Delegated Report

Householder Planning Application

Planning Application No: 20250169

Description: Replacement PVCu Windows to front and rear elevations in white with Astragal Bars and Replacement door in Black Composite and Black PVCu frame.

Existing Property Front

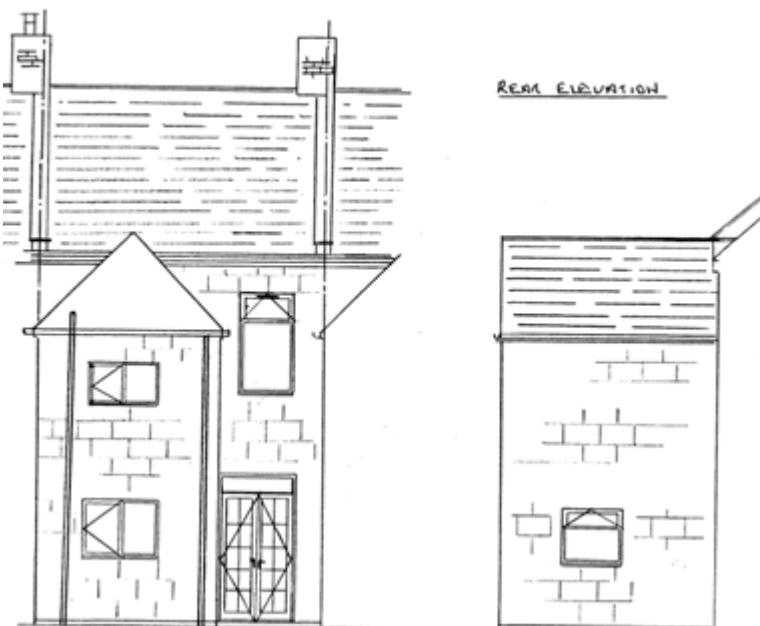
As can be seen from the above images, the ground floor front window is original timber sash. The first floor front windows and windows and doors in the rear elevation are uPVC.

As stated, the existing ground floor front window is original/period fabric sliding sash windows and is elegant and fine proportions with single glazing. Therefore it's replacement with a standard uPVC unit would be unacceptable and contrary to Policies CS19 and CS20 (LPCS), saved Policy TC3 (LPFR) and section 16 (NPPF, 2024).

The first floor windows and the rear windows and doors are modern uPVC replacements and overall the principle of their replacement is acceptable, subject to design. Whilst the existing uPVC windows appear to be standard uPVC units, an application for their replacement would present an opportunity to secure a design that would be more fitting of the period and original window design of the property, such as uPVC vertical sliding sash windows. It is important to note that the replacement of the windows on the rear elevation would not require consent and so are of a lesser concern. However the windows on the front elevation are significant.

Proposed Windows / Doors

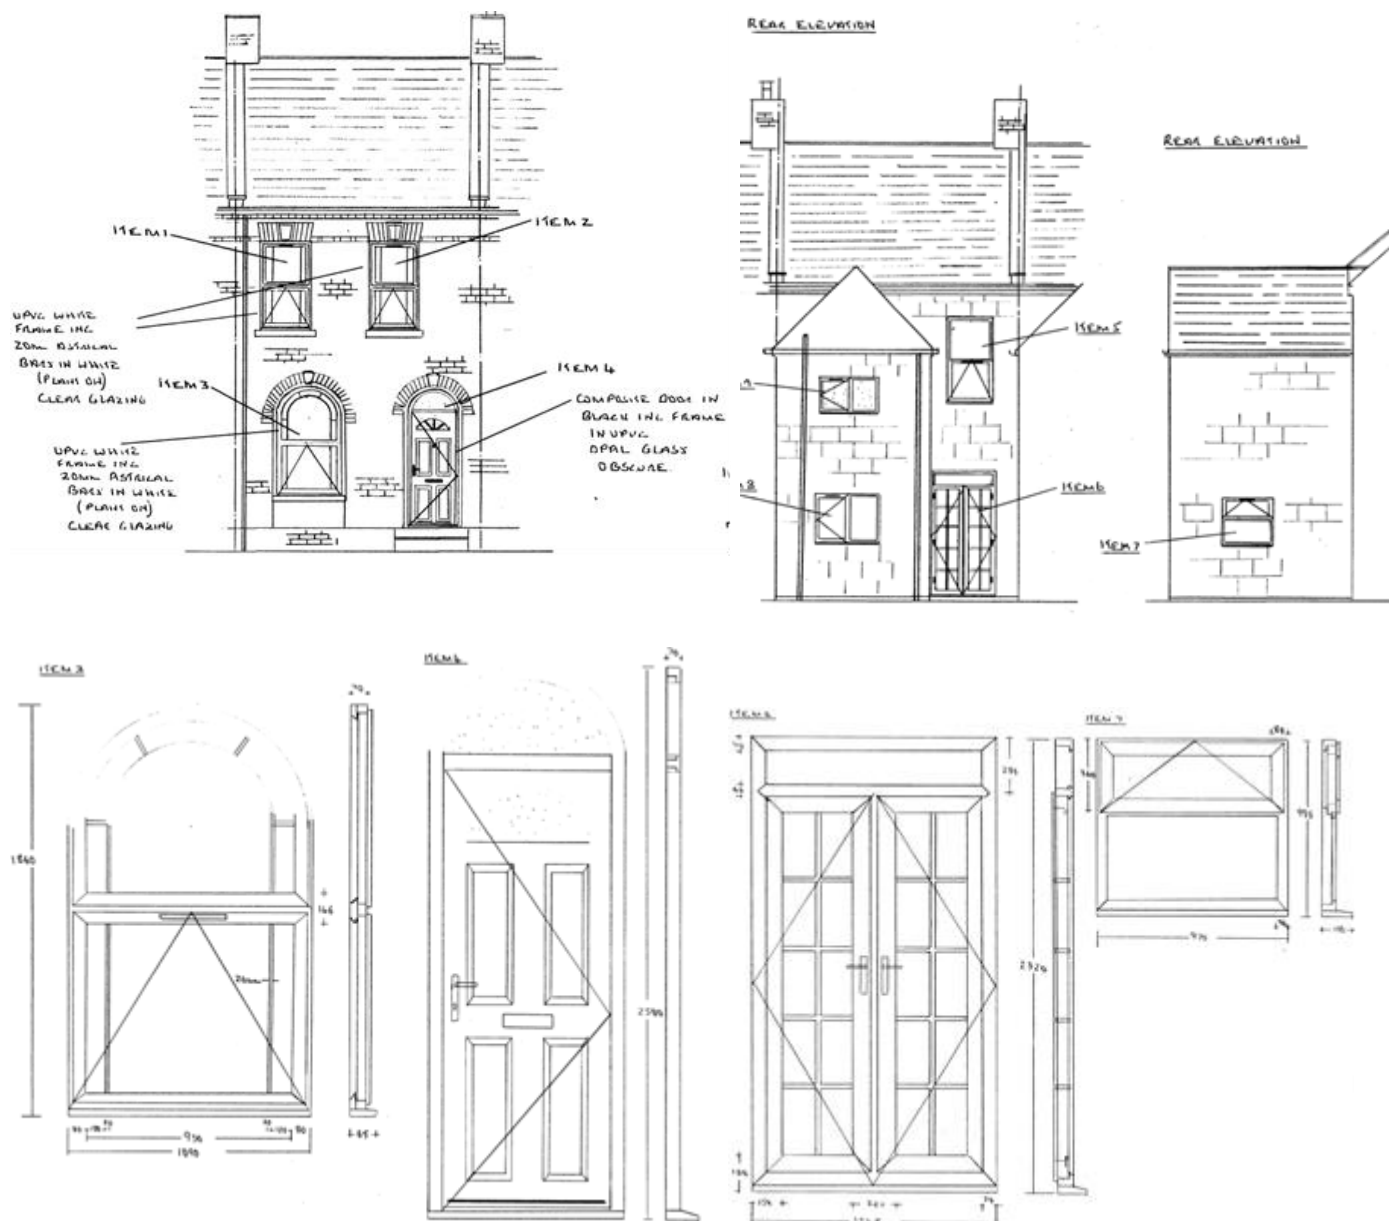
The existing uPVC windows and the proposed replacement windows are of chunkier proportions when compared to the original/period fabric windows as evident from the thickness and depth of the meeting rail, frame and glazing bars which is due to the use of uPVC rather than timber. The windows lack the finesse of the original/period windows. The spacer bar due to the double glazing is another jarring

feature adding to the unacceptability of the detail of the windows.

The replacement windows in terms of being plastic, of thicker proportions, double glazing and a lack of finesse compared to the existing ground floor front window and the original/period fabric windows that have been historically removed would not preserve or enhance the character or appearance of the King Street Conservation Area but will cause further harm to it.

The proposed replacement door is also not considered appropriate both in terms of it's design and material and would fail to preserve or enhance the conservation area setting.

Overall, therefore it is considered that the proposed replacement windows by virtue of their material, design and detailing do not preserve or enhance the character or appearance of the King Street Conservation Area but will cause harm to it. As such, the proposal is contrary to Policies CS19 and CS20 (LPCS), saved Policy TC3 (LPFR) and section 16 (NPPF, 2024).

It is stated in the Heritage Statement that the existing windows and doors have now become very inefficient and draughty and beyond economical repair. As already stated, the replacement of the existing uPVC windows is principally acceptable, however the local authority would like to see uPVC vertical sliding sash windows to reflect the original design of the property. With regard to the original ground floor timber sash window, this window does not appear to be in a state of disrepair and from the officer site photos, appeared to be well preserved. The Council declared a Climate Emergency in June 2019 and retention and re-use is therefore more important than ever and renovating and reusing old materials is fundamental in helping to tackle these issues. A timber window is very rarely wholly unrepairable.

The applicant's comments regarding the condition of the windows are noted however, for the reasons above this is not considered to outweigh the harm that has been found. Furthermore, in respect of the matter of the condition of the windows, the windows proposed with relation to the replacement of the existing uPVC windows are not the only option to address this matter. The replacement of the original timber sash window with the proposed windows is also not the only option; should it have been able to have been demonstrated that this window is wholly beyond repair. Its replacement with timber slim-lite sliding sash windows would could potentially address the matter of condition.
